Model: V-C2	Date: 15-Nov-07	No.: RD014001o
-------------	-----------------	----------------

Subject: Firmware Release Note: Engine		Prepared by: C. Shimaji	
From: 1st Tech Service Sect., MFP/Printer Tech Service Dept			
Classification:	<input type="checkbox"/> Troubleshooting	<input type="checkbox"/> Part information	<input type="checkbox"/> Action required
	<input type="checkbox"/> Mechanical	<input type="checkbox"/> Electrical	<input type="checkbox"/> Service manual revision
	<input type="checkbox"/> Paper path	<input type="checkbox"/> Transmit/receive	<input type="checkbox"/> Retrofit information
	<input checked="" type="checkbox"/> Other ()

This RTB has been issued to announce the firmware release information for the **Engine**.

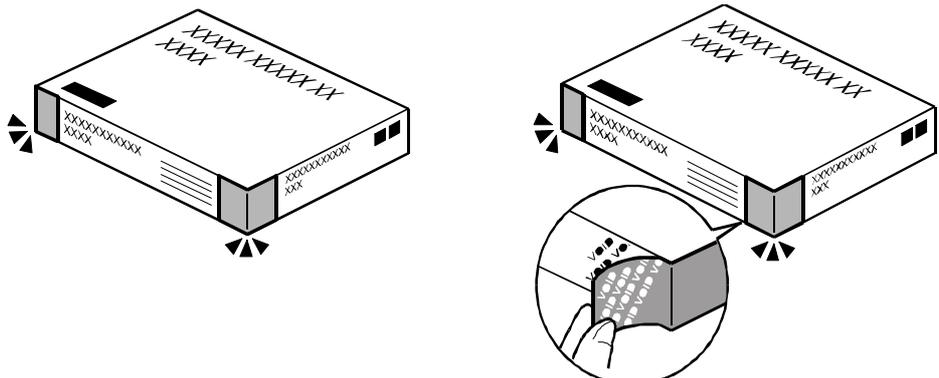
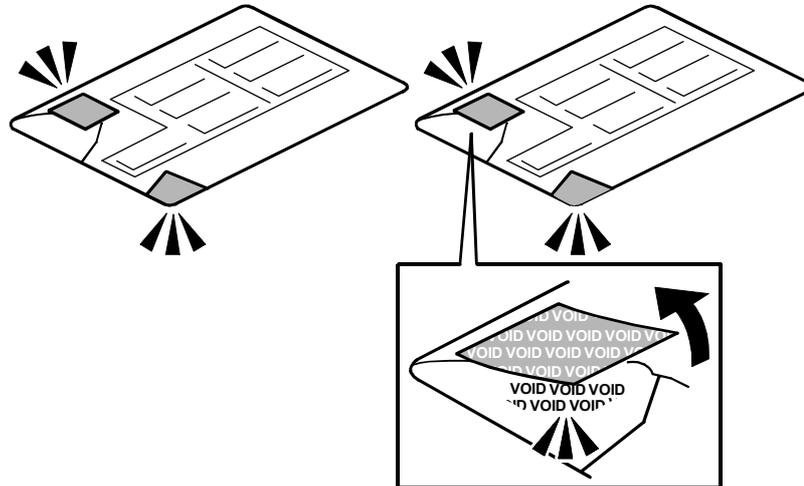
The illustration of package has been corrected.

Correct:

Development Unit

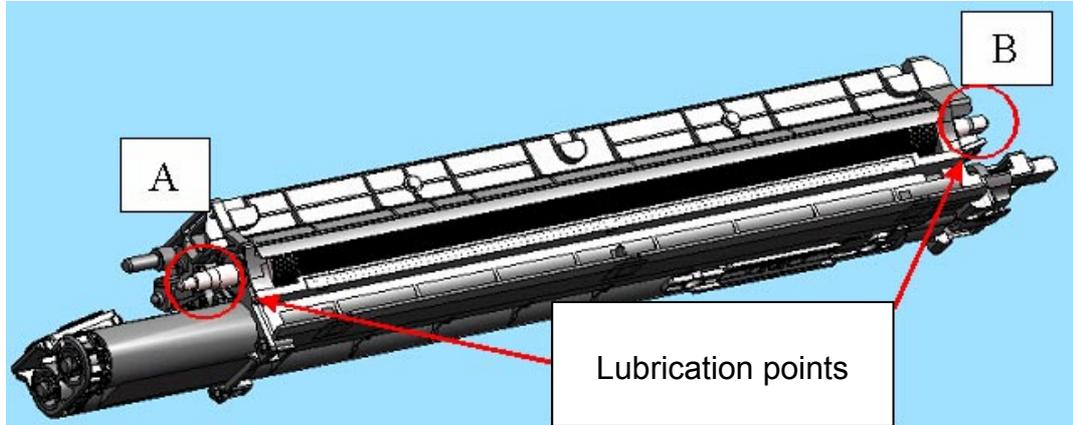
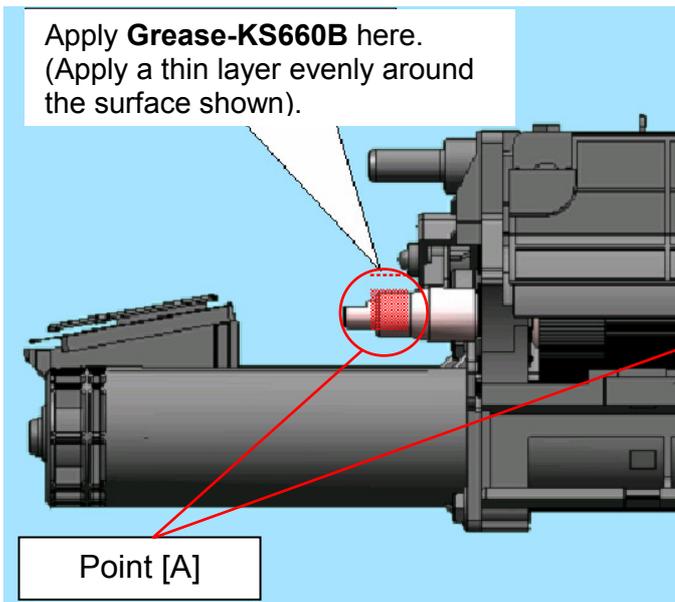
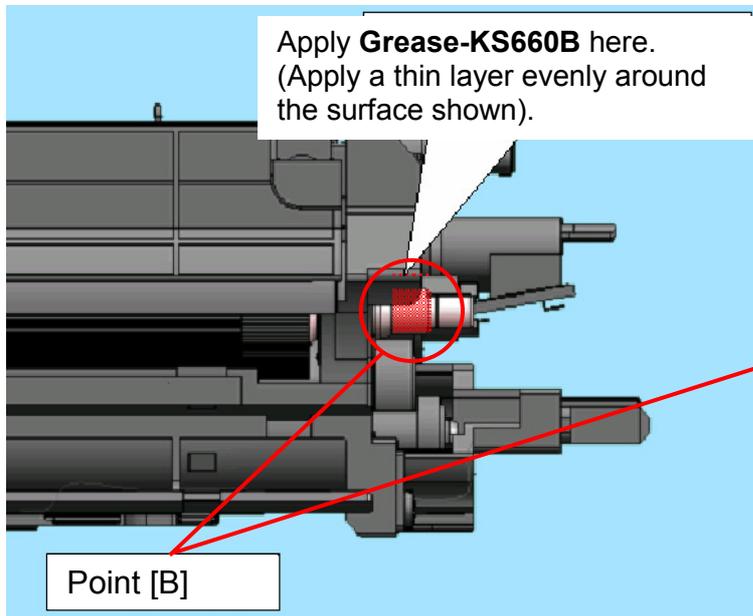
- **Add** the new illustration as follows (pg. 255, Lubrication Points):

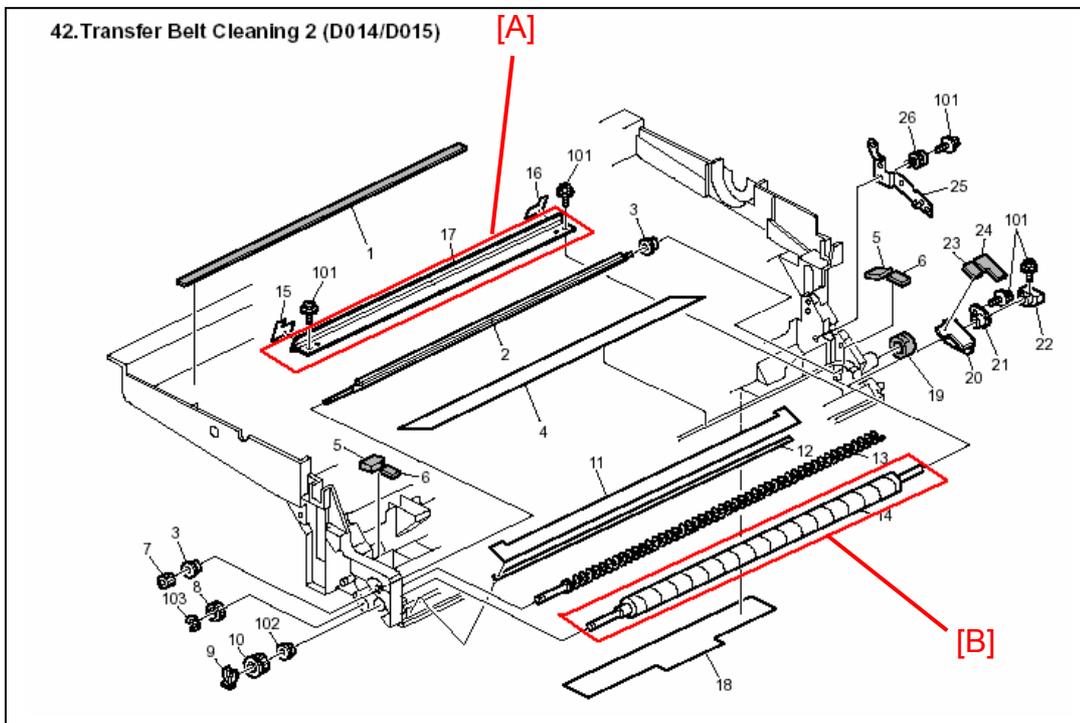
A manufacturing error in the brush scraper [A] causes damage to the ITB cleaning brush [B].

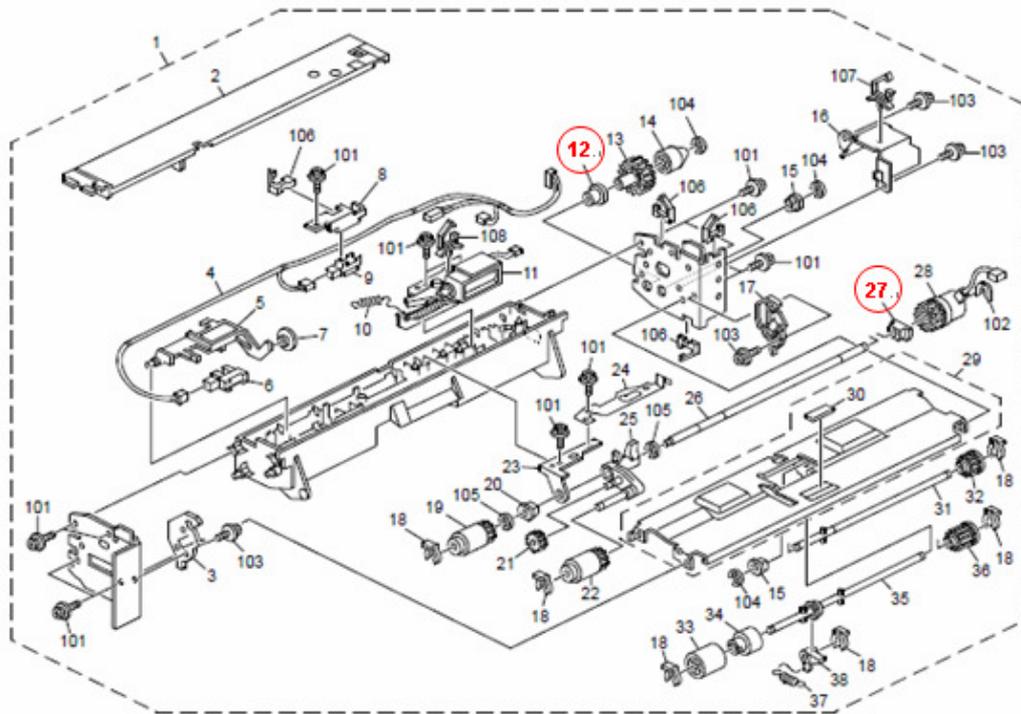
Change: The following indexes were corrected.

35.PCU 2 (D014/D015)

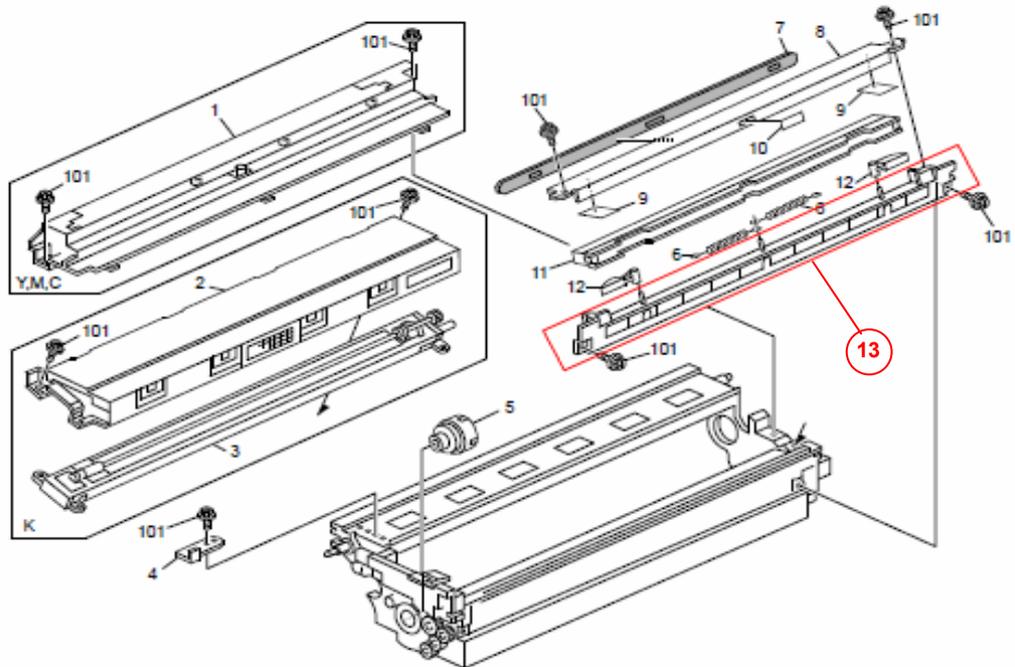
Note: The following part was registered as a service part.

70. Drive Section 4 (D014/D015)

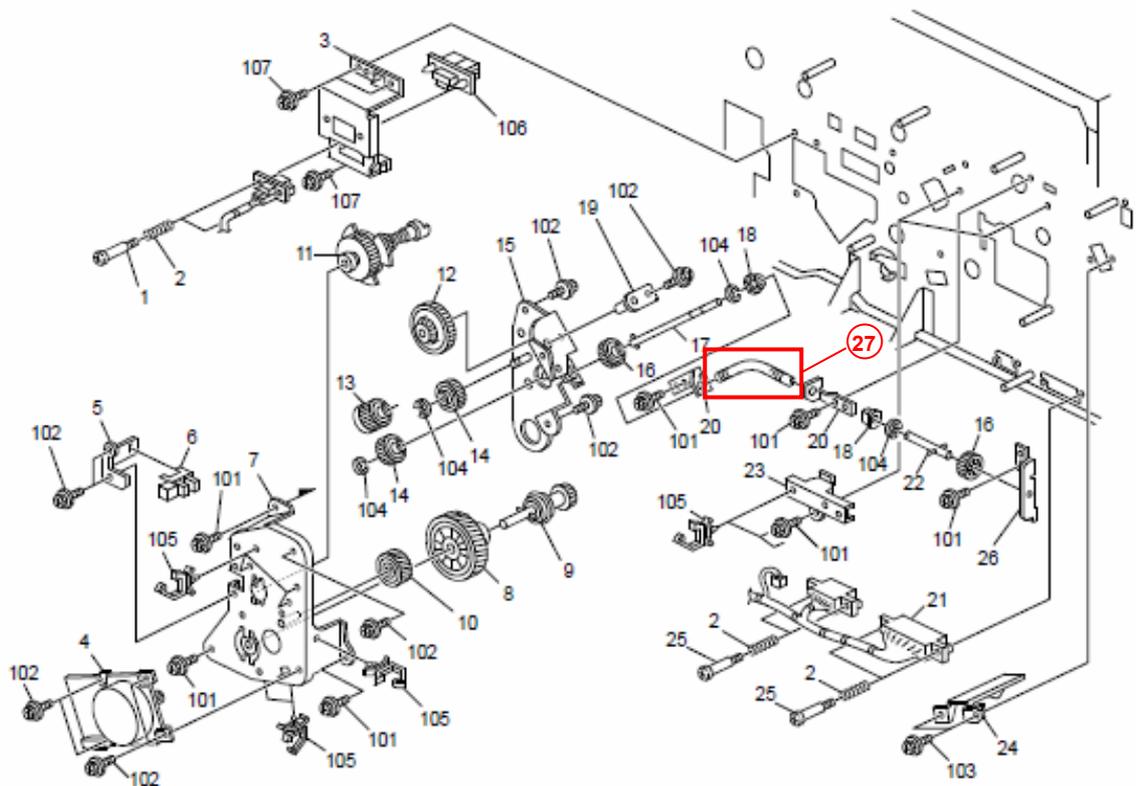
The part circled below (Index#27) has been registered as a service part.

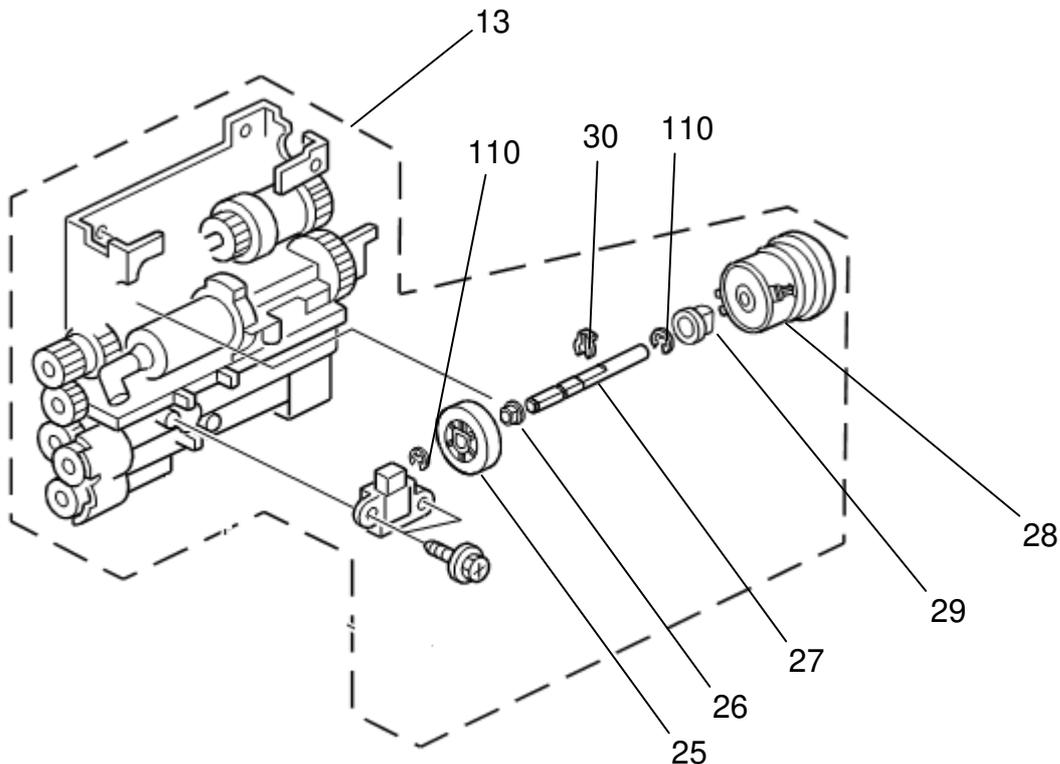
Change: The parts in the table were added.

Reason: To meet requests from the field.

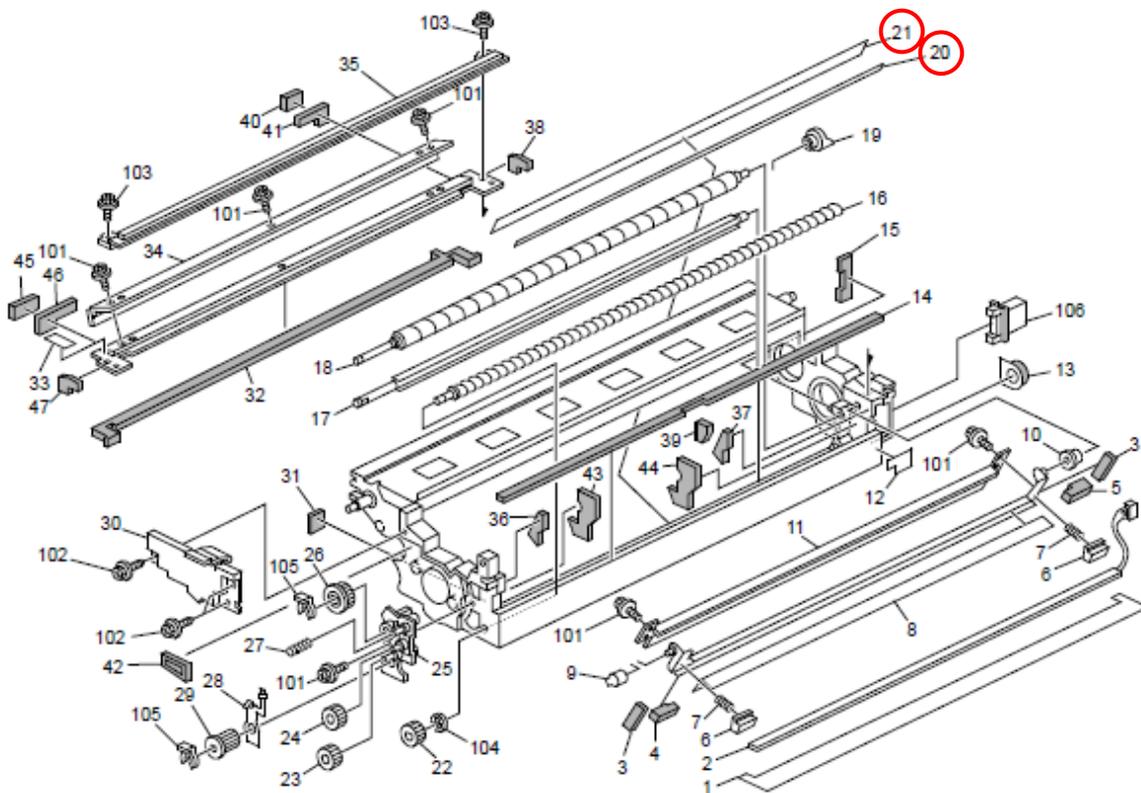
Change: The parts in the table were deleted.

Reason: These parts cannot be replaced in the field, since they are attached to the machine frame at the factory using precision tools.

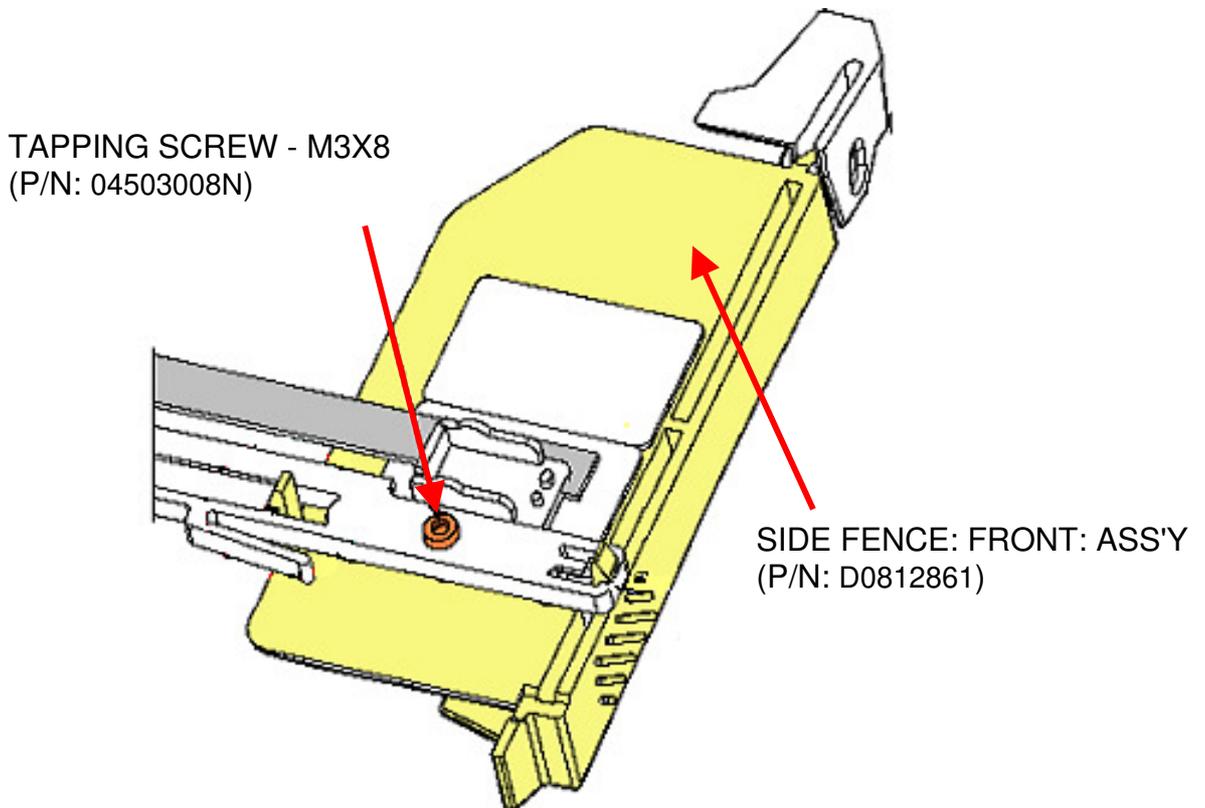
Change: A tapping screw (M3x8) was added to the side fence front assembly.

Reason: To fix the assembly in place, so that it does not detach from the hook when it is slid.

50.Fusing Unit 2 (D014/D015)

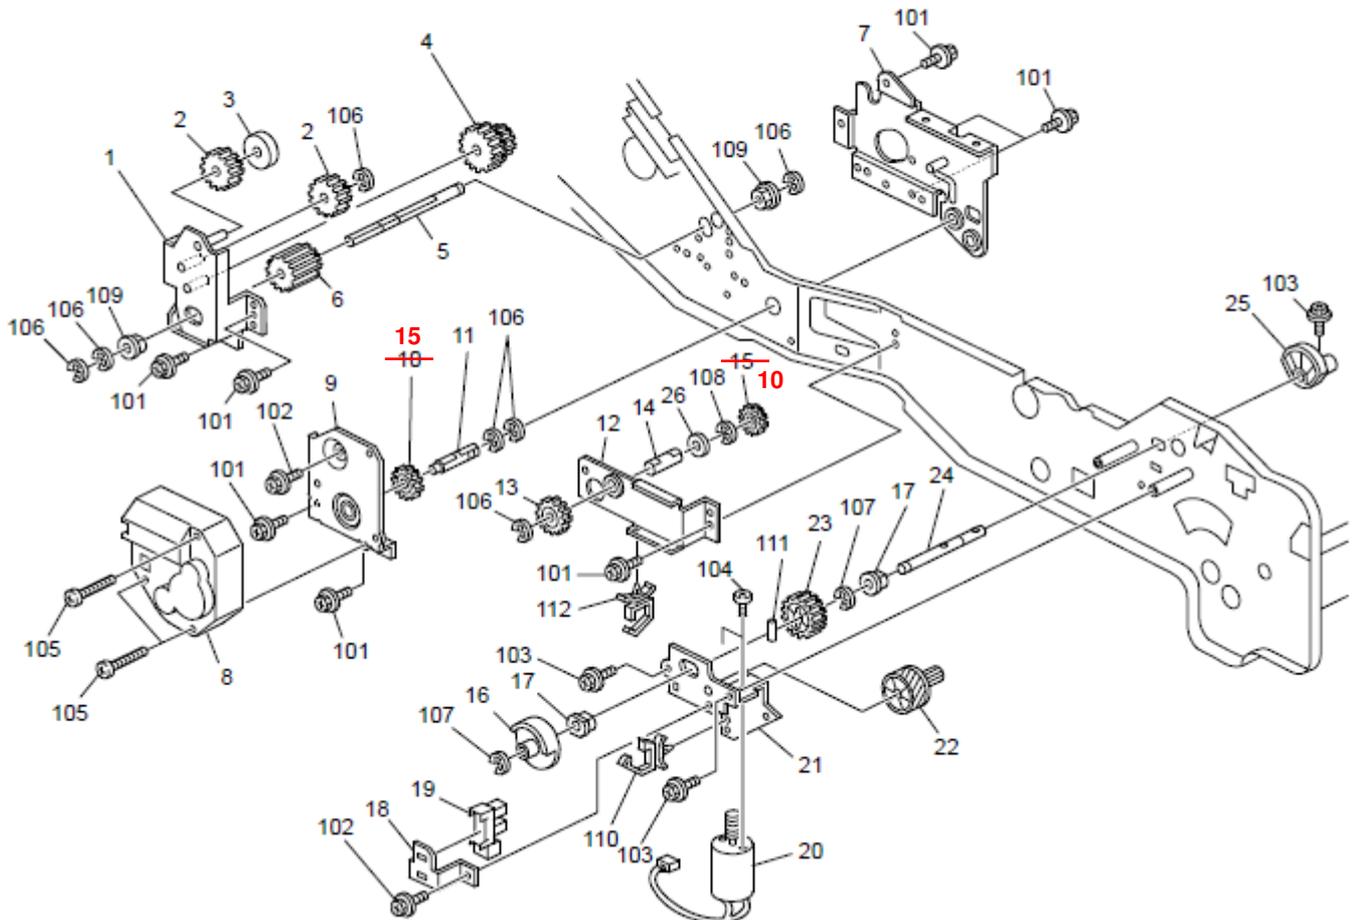
Index No.	Part No.	Description	Q'ty	Page	Note
10	AB014310	Gear: Motor: On-Off	1	117	<i>Helical Gear</i>
15	AB014312	Gear: Motor	1	117	<i>Straight Gear</i>

12.Original Exit 2 (D014/D015)

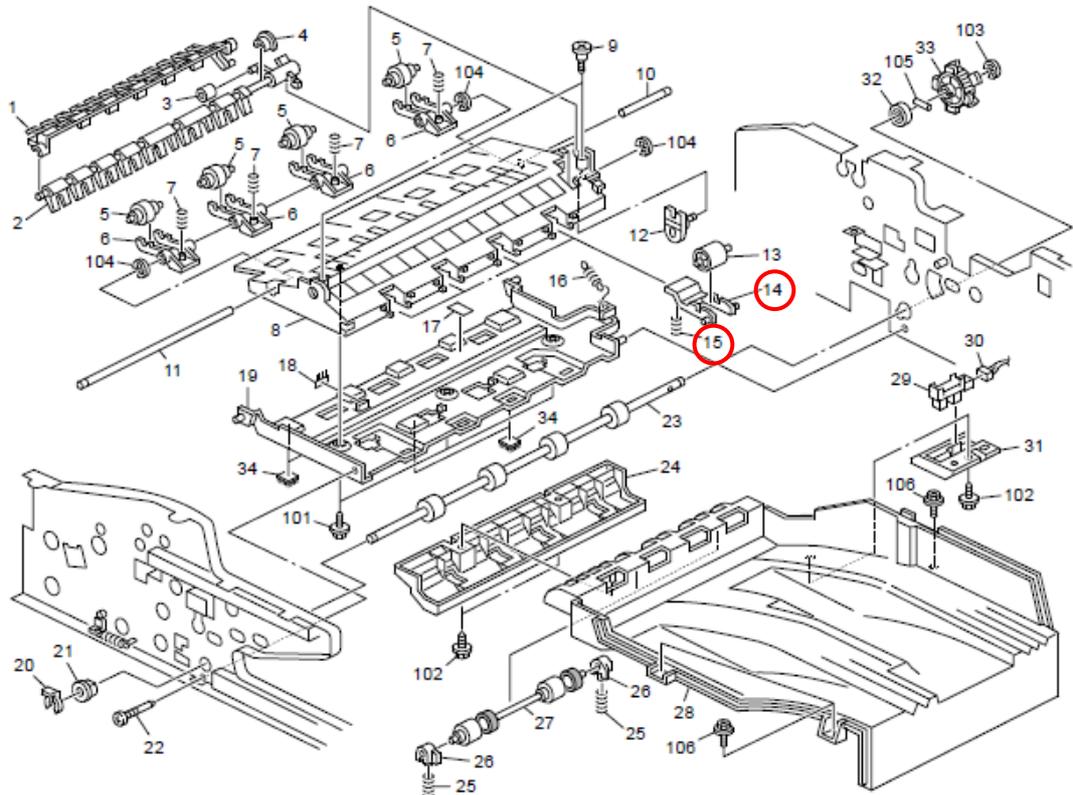
Note: Install both new parts **together as a set**.

47.Paper Transfer 1 (D014/D015)

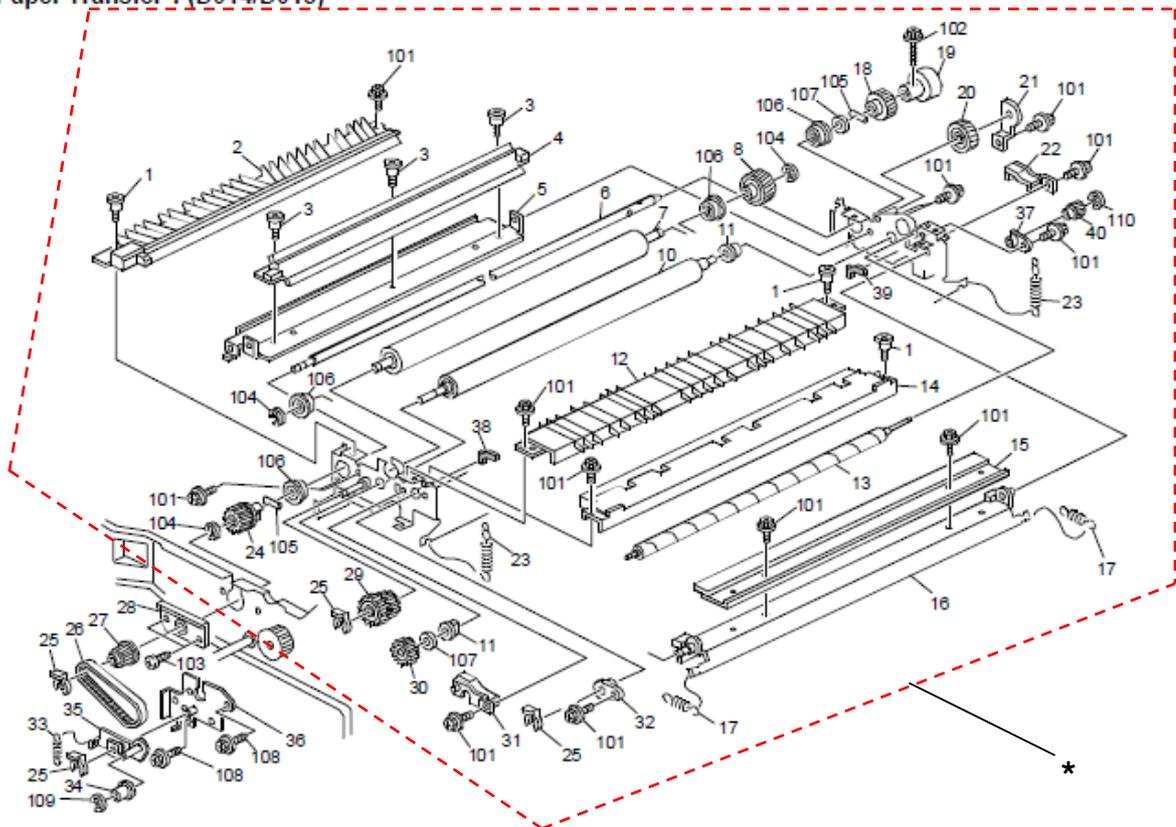
Change/Reason: The parts information for the paper transfer unit was added to the D014/D015 Parts Catalog.
